<b><u>R-24-62</u></b>	<b><i>Staff Report – December 2, 2024</i></b>
<b><i>Application Type:</i></b>	Resubdivision
<b><i>Project Address:</i></b>	301 Wolf Street & Park Street (002.-04-10.0) 1920 Park Street (Tax ID: 002.-04-02.4) 311-21 Wolf Street (Tax ID: 002.-04-09.0)
<b><i>Summary of Proposed Action:</i></b>	The applicant proposes to undertake a historic rehabilitation project of the existing 301 Wolf St. and 1920 Park St. properties which includes combing three adjacent lots into one. Two of the properties are listed on the National Register while 311-21 Wolf Street is not listed. The purpose of this resubdivision is for the development of a mixed-use project which includes both residential and commercial use.  New Lot 100 square footage: 33,976.8 SF
<b><i>Owner/Applicant</i></b>	Jamin Brown, Wellington Ward LLC (Owner of 301 Wolf St. & Park St., 1920 Park St./Applicant) 300 Wolf St LLC (Owner of 311-21 Wolf St.)

<b><i>MaSPR-24-36</i></b>	<b><i>Staff Report – December 2, 2024</i></b>
<b><i>Application Type:</i></b>	Major Site Plan Review
<b><i>Project Address:</i></b>	1920 Park St. (Tax Map ID: to be assigned)
<b><i>Summary of Proposed Action:</i></b>	The applicant is applyin

**PLANTING & FINISH PLAN**

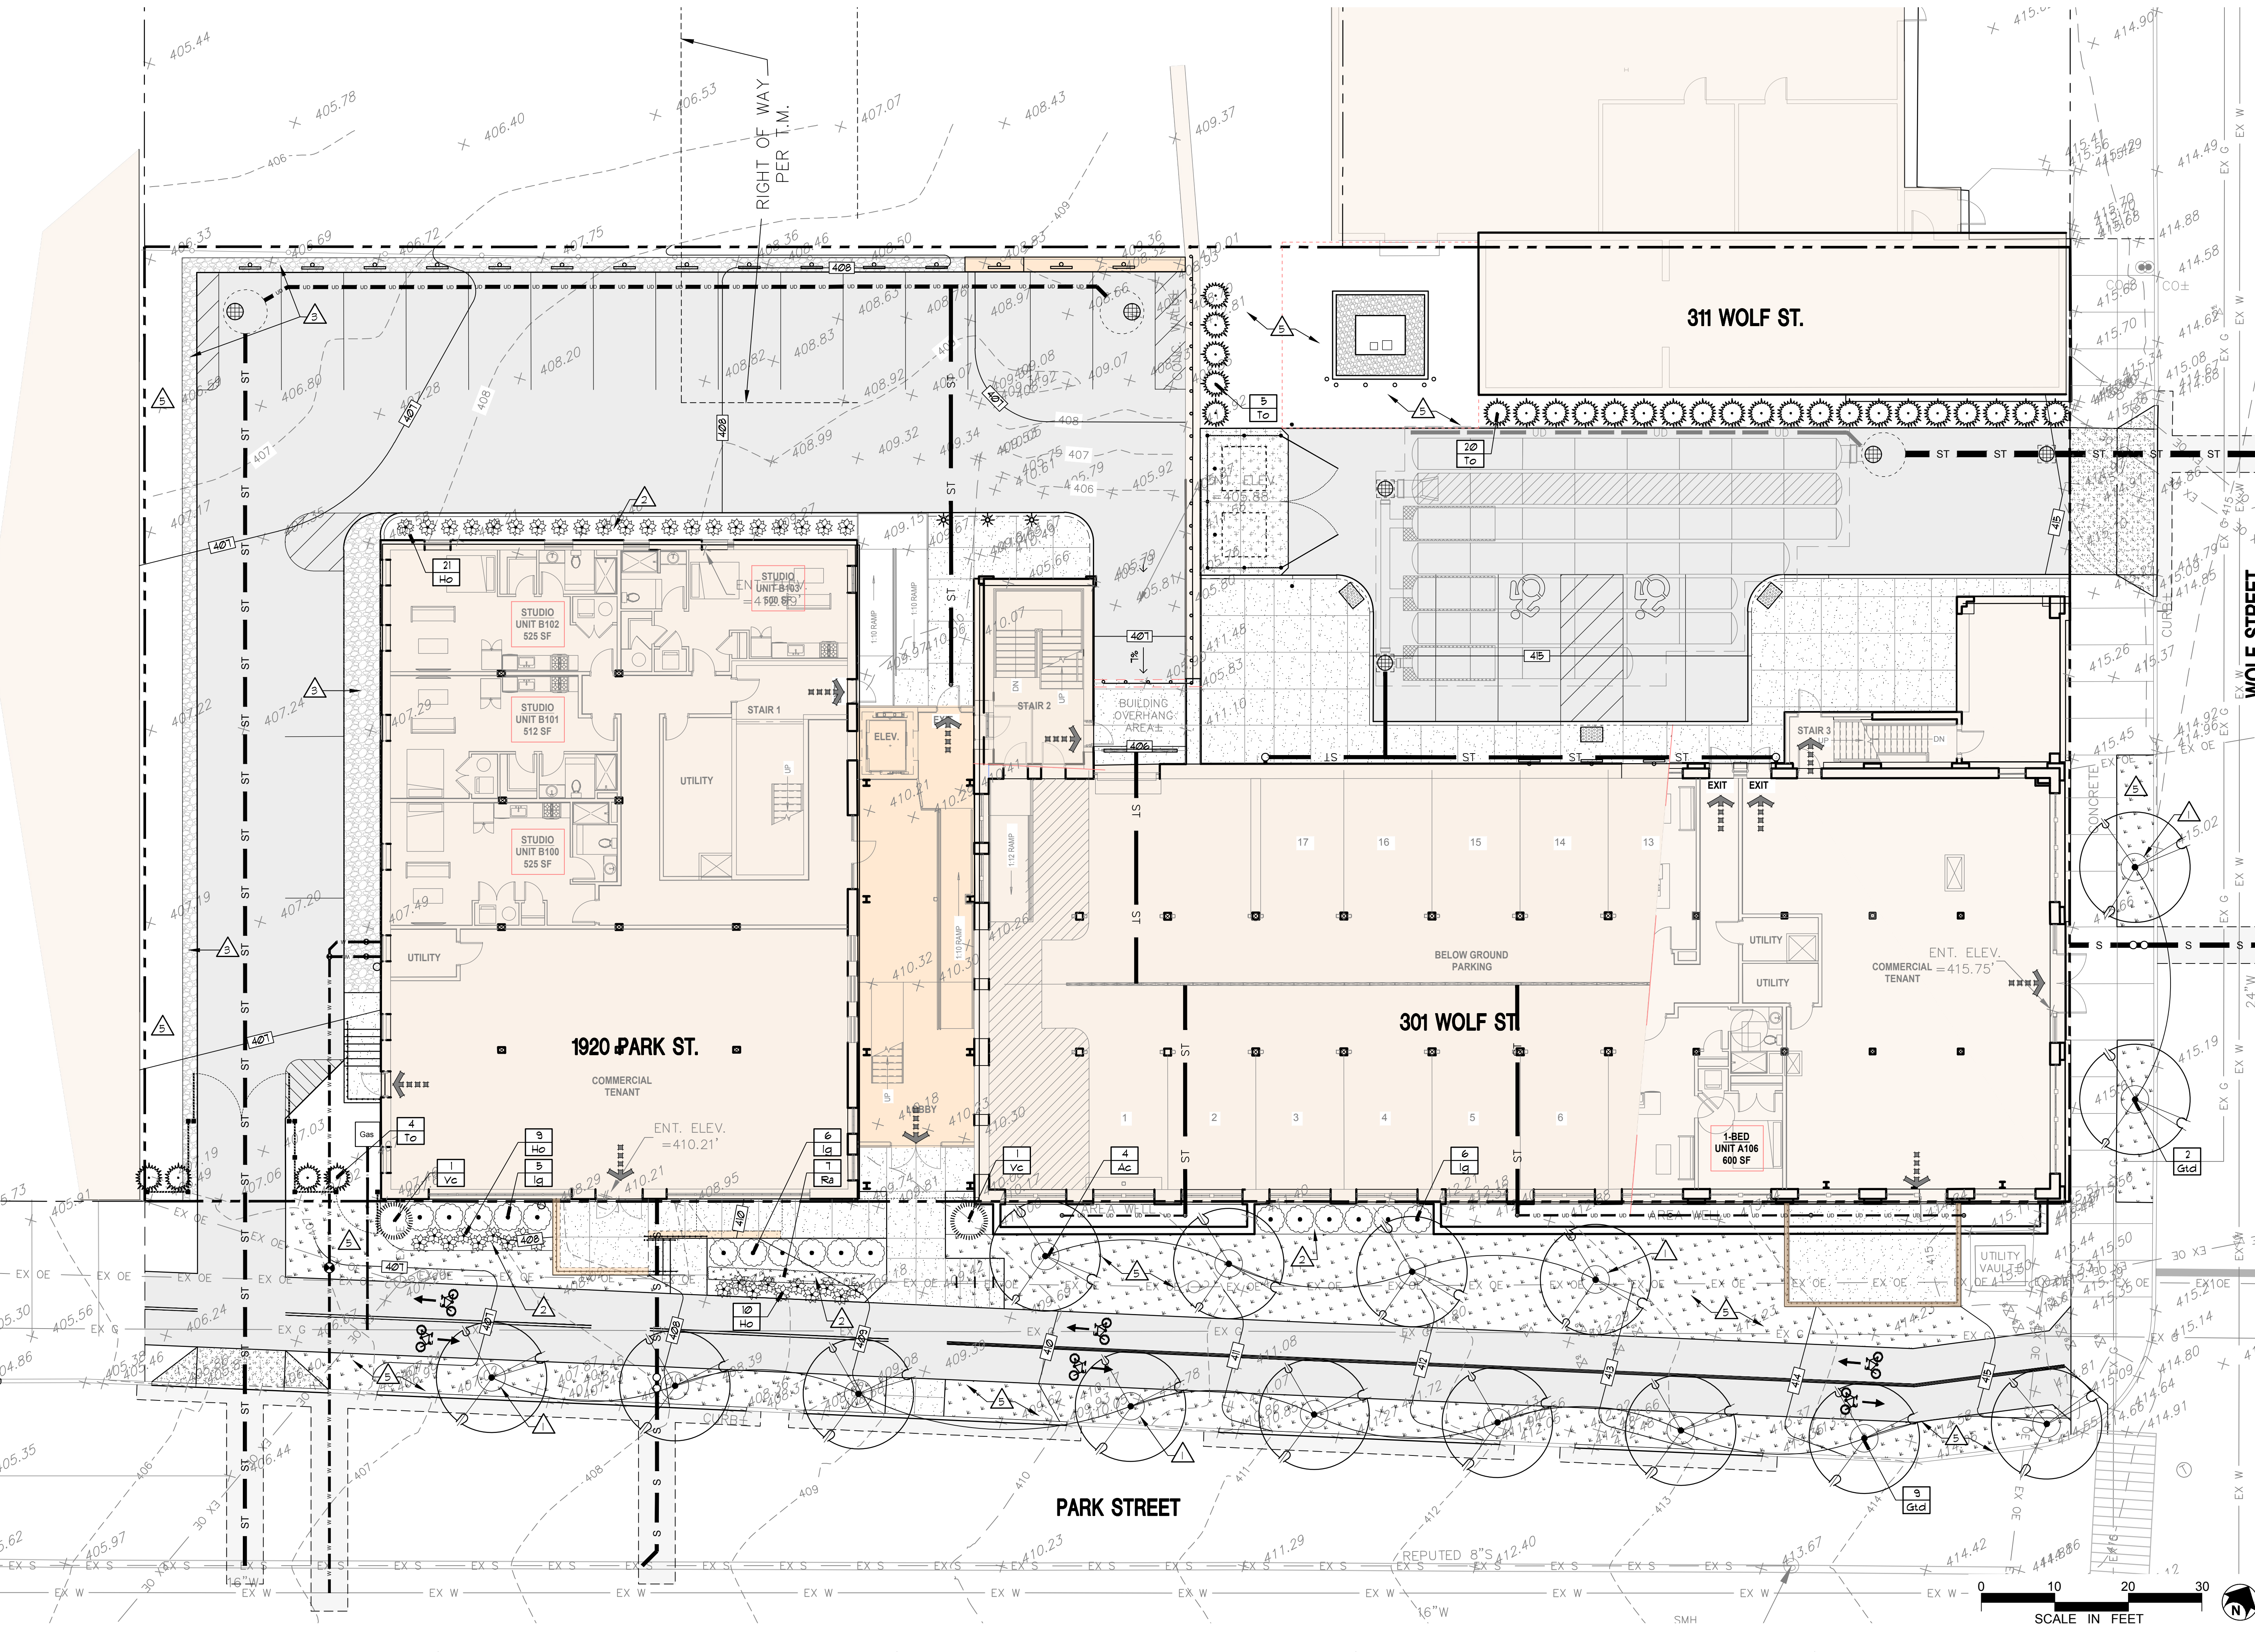
Parks - Forestry	Approved	11/06/2024	Jeff Romano	Provide CU soils along the 'tree lawn' and under the SUP along both Park Street and walks along Wolf Street. (10'x15'x3' of CU soils, minimum 4'x7' tree opening). What is the hatch pattern along the sidewalk at 1920 Park St? Will the existing overhead electric lines be removed or relocated? Tree species selection; shorter trees under wire; Amelanchier, Cercis, Cornus, Carpinus. No overhead wire; Celtis, Ostrya, Quercus. Sheet L4.0 - scale is wrong
Planning Commission	Pending	10/07/2024		
Eng. Design & Cons. - Zoning	Conditionally Approved	10/18/2024	Mirza Malkoc	• All construction in the R.O.W. will require a permit, all construction in the R.O.W. to be per City standards
